GOVERNMENT OF THE DISTRICT OF COLUMBIA
OFFICE OF PLANNING

MEMORANDUM

SUBJECT: LTR 2002-02, Fort Totten East Apartments - **Modification**

Figure 3 Retail Plaza

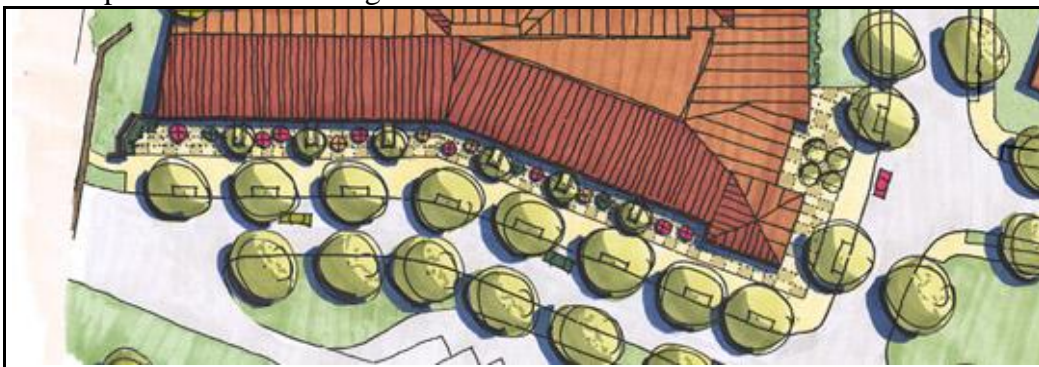
- Provide additional foundation plantings for all buildings.
- Between Hamilton and the public alley to the east, the planting strip should be about six feet wide with a six-foot wide sidewalk. Third Street can have a five-foot wide sidewalk with a six foot planting strip. The applicant has agreed to this design.
- Sidewalk material along Hamilton should be decorative (e.g., brick). The large expanse of concrete closest to the metro station in front of the retail spaces should also be decorative as well as the plaza areas at the corner of 3rd Street and Hamilton Street. In response, the applicant redesigned the intersection of 3rd and Hamilton to pull the retail up closer to the Metro station, keeping the existing travelway bounding the north side of the kiss-and-ride and terminating Hamilton at a plaza as shown in Figure 3.
